End Ring O-Ring?

Alex Eslinger (JLab)

5/13/24

End Ring (Sketch View)

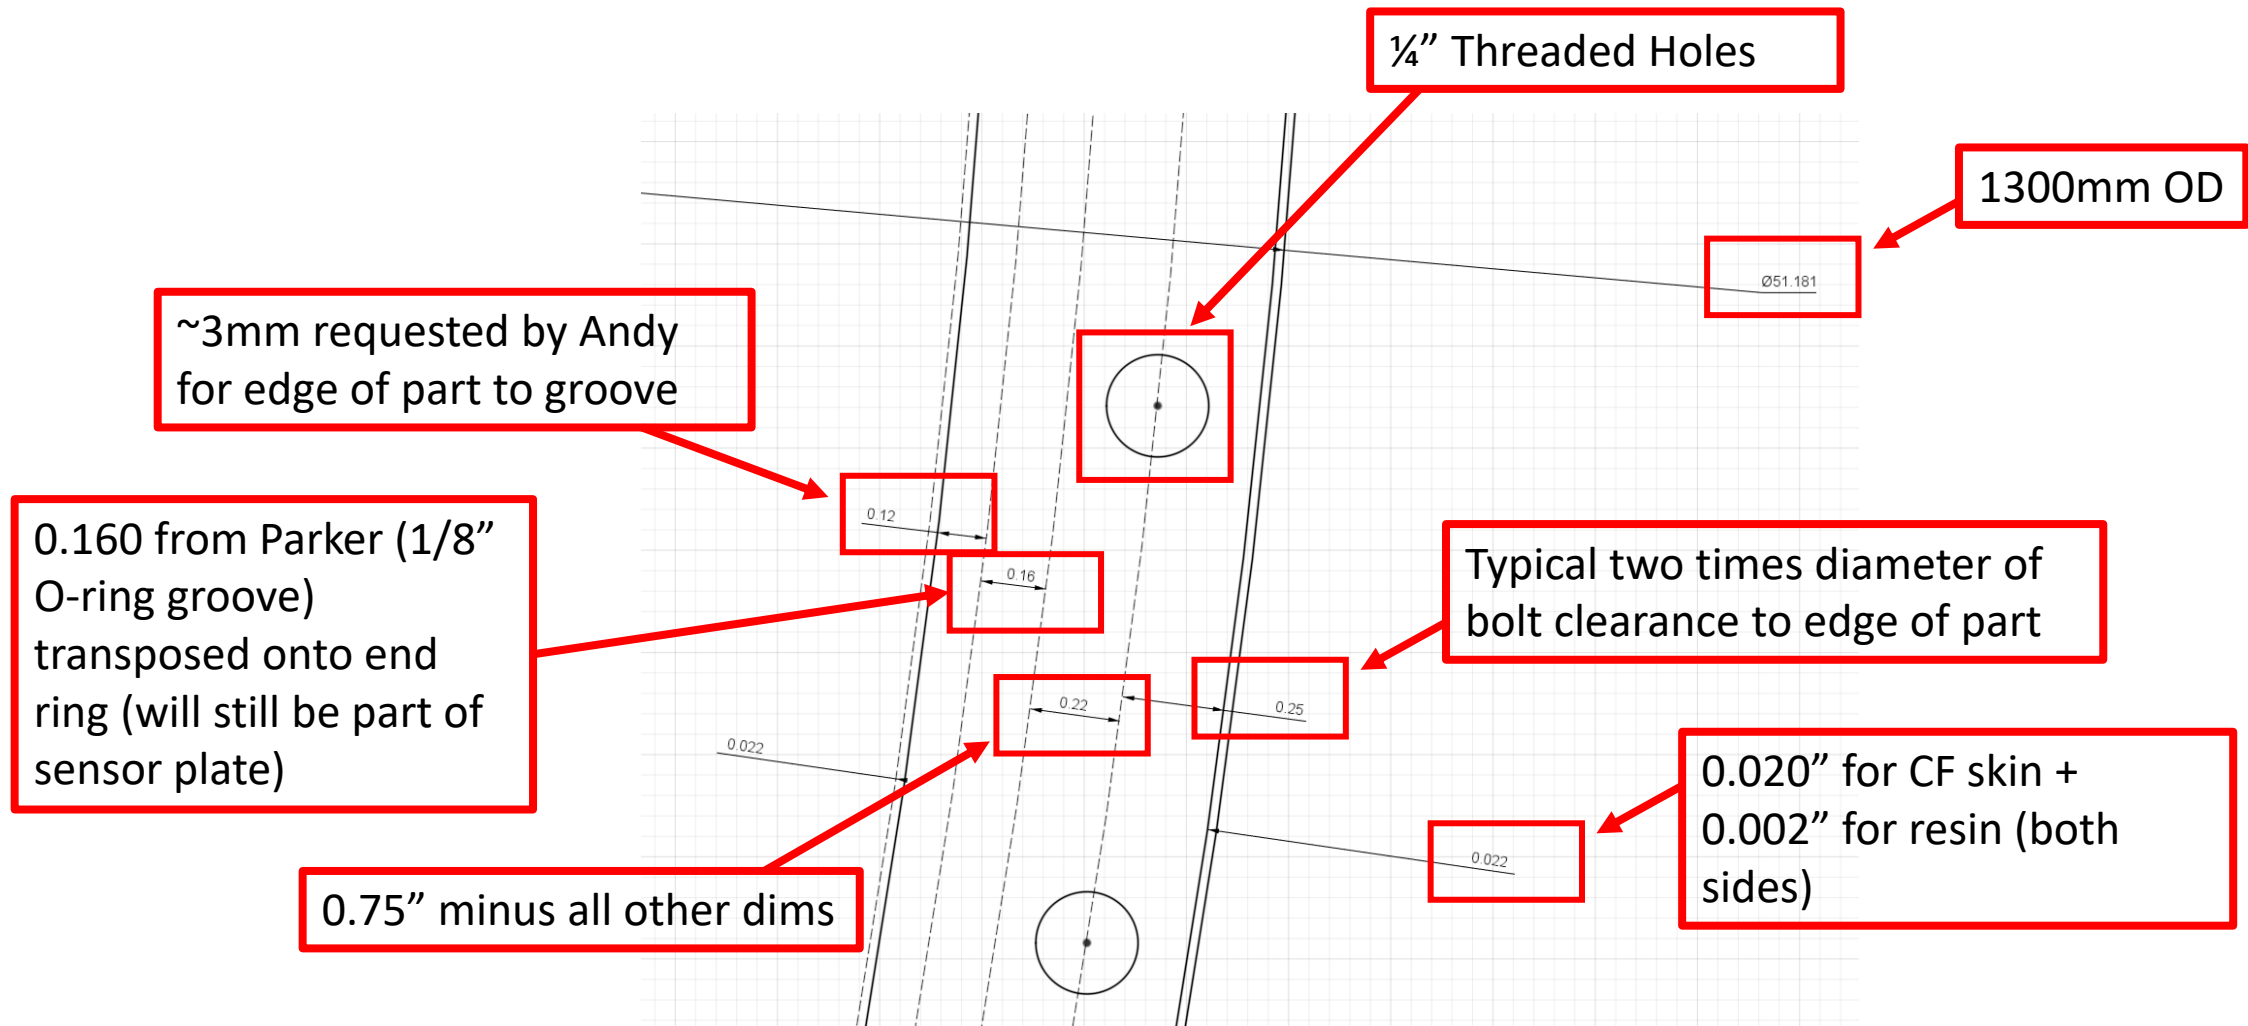
- The current design for the sensor plate o-ring groove is problematic since there are areas of the sensor pocket design that leave insufficient material between the o-ring groove and the sensor pocket itself (shown in last week's meeting).
- The first solution that was proposed was to locally or globally thicken the sensor plate by an estimated 2mm in order to move the sensor pocket further away from the o-ring groove.
- Another proposed solution was to move the o-ring groove to the end ring.
- Since moving the o-ring groove back to the end ring was the least interruptive, I spent some time investigating it first. However, the machining for this groove (if chosen as the way ahead) would be completed while the end ring is still in sections. This meant that until this decision was made, Purdue would be delayed on bonding the end ring.

Updated End Ring (Sketch View)

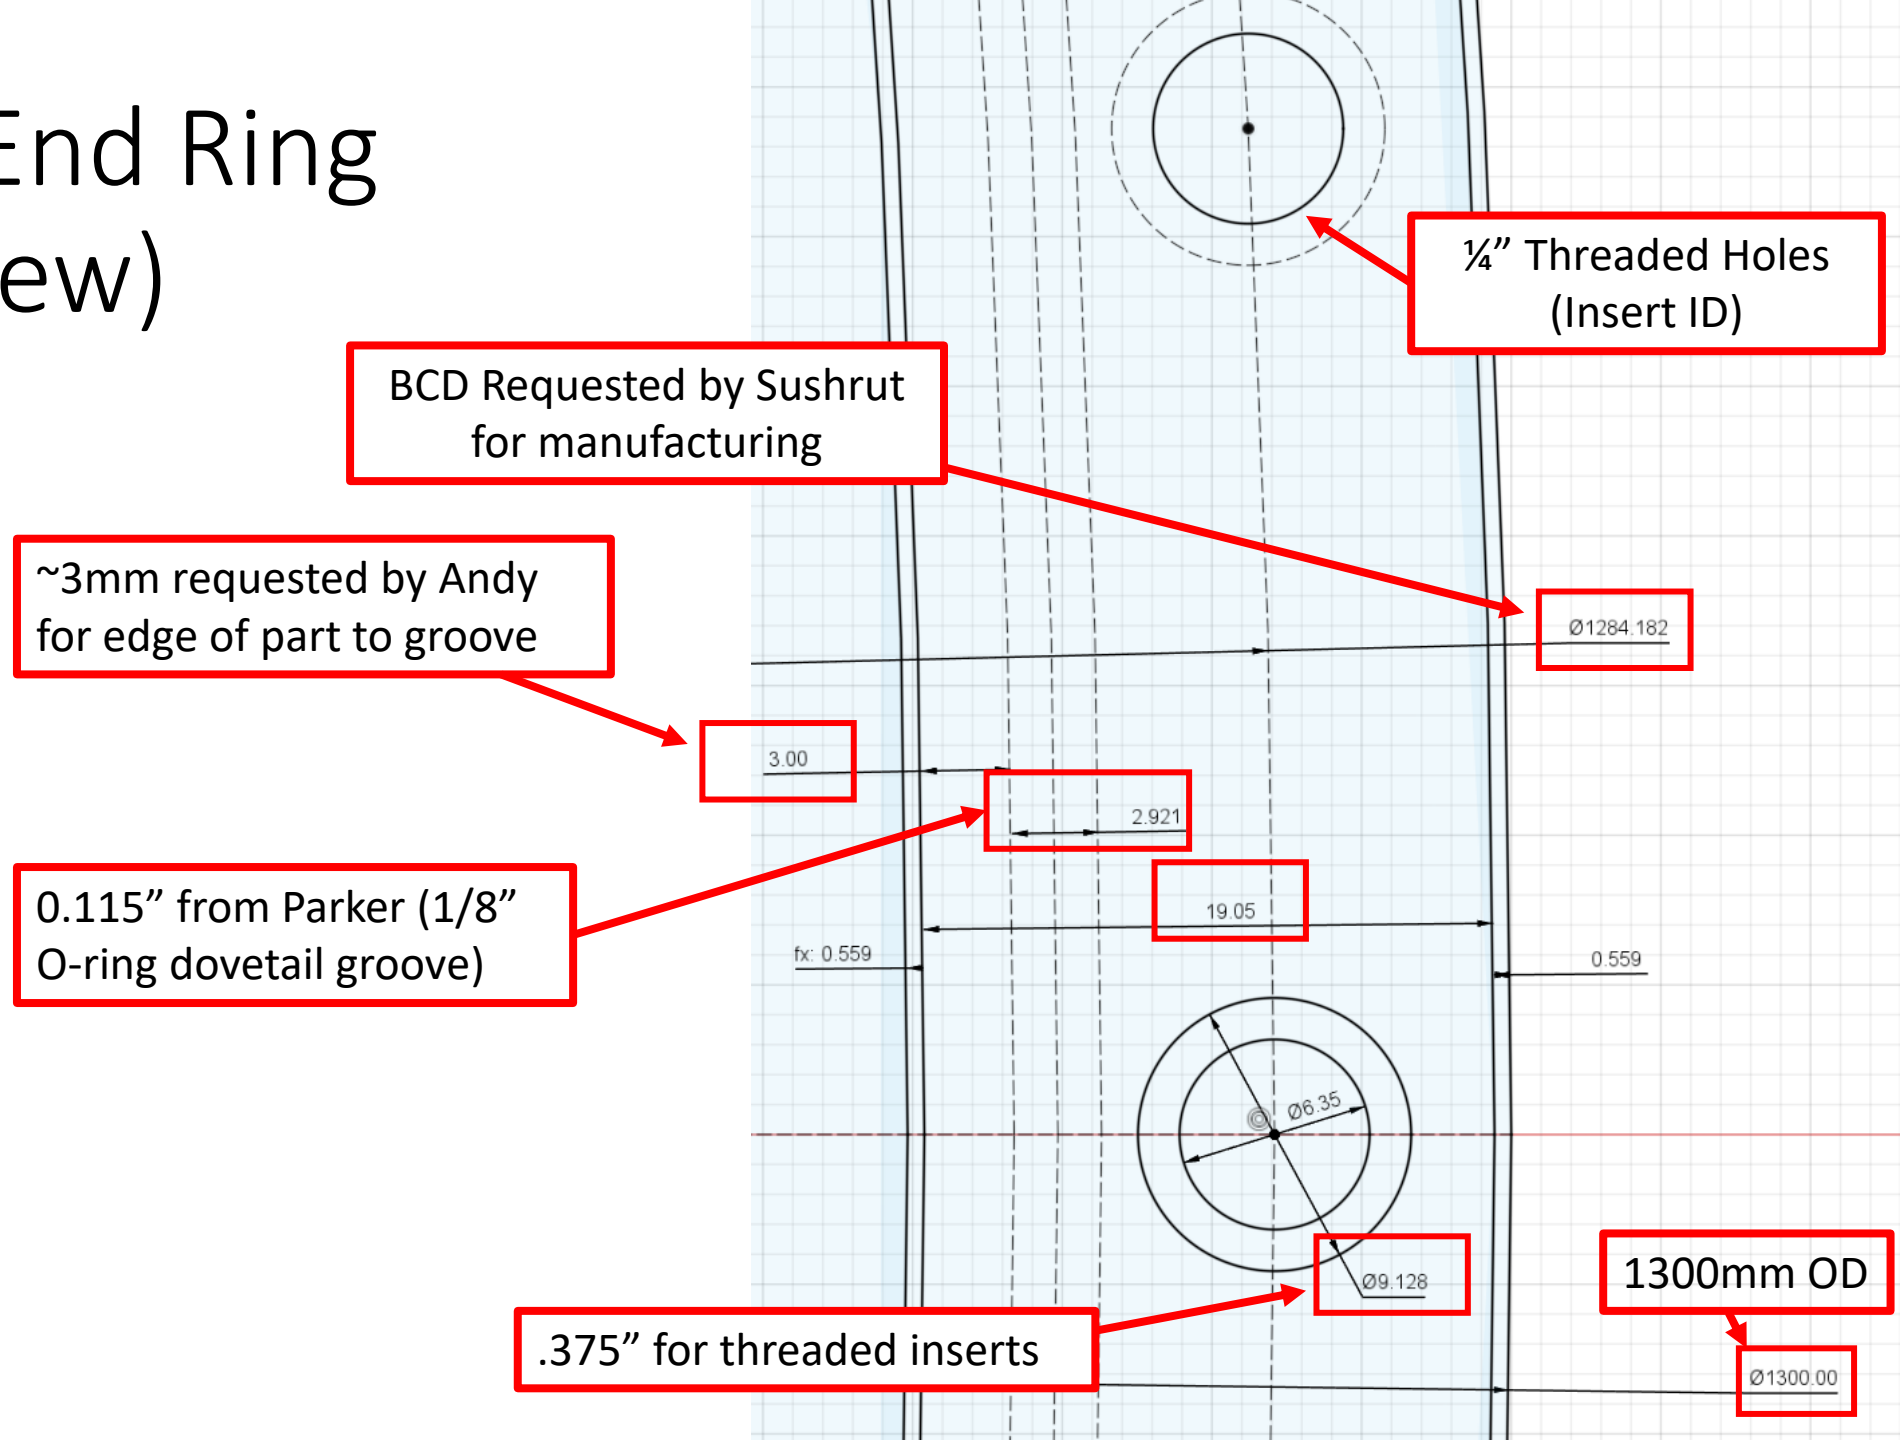
- If we were to go ahead with the manufacturing of the end ring o-ring groove, it is extremely likely that we will have material tear-outs along the o-ring groove in the locations of the inserts (120 places).
- The inserts are not fully encapsulated in an epoxy, they are merely brushed in the middle with epoxy before installation. Meaning there are voids between the outer threads and the carbon fiber.
- Moving forward with machining the o-ring groove into the o-ring would create 120 points of possible leakage around the vessel.
- Therefore, I recommend we keep the o-ring groove on the sensor plane and proceed with a local or global thickness change to the sensor plane.
